Product Change Notification

Product Group: SFERNICE / **April 26th 2021** / **PCN-SF-259-2020 Rev 2**

SFERNICE PRECISION POTENTIOMETERS

ECO50 (Tap Option) – Co-molded tap + Marking

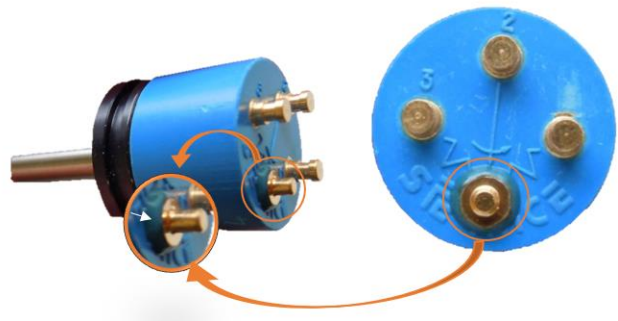
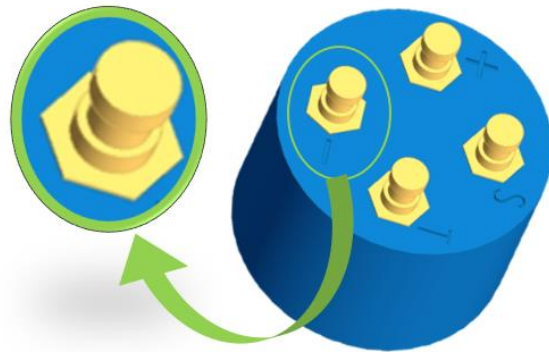
DESCRIPTION OF CHANGE: In line with our commitment for continuous improvement, the process of mounting the 4th turret on the housing changes from "screwing + gluing" to a single co-molded part (turret + housing). At the same time, the SFERNICE brand is removed from the marking and identification method changed (figures to signs/letter). *See pictures page 2*

FORMER CONFIGURATION

- Screwing + gluing of the 4th turrret on the housing.
- Sfernice Brand
- Pins identification by figures "1-2-3-4"

NEW CONFIGURATION

- Single co-molded part - turret /housing
- "Sfernice" Brand removed
- Pins identification by signs (+ / -) and letters (S & T)
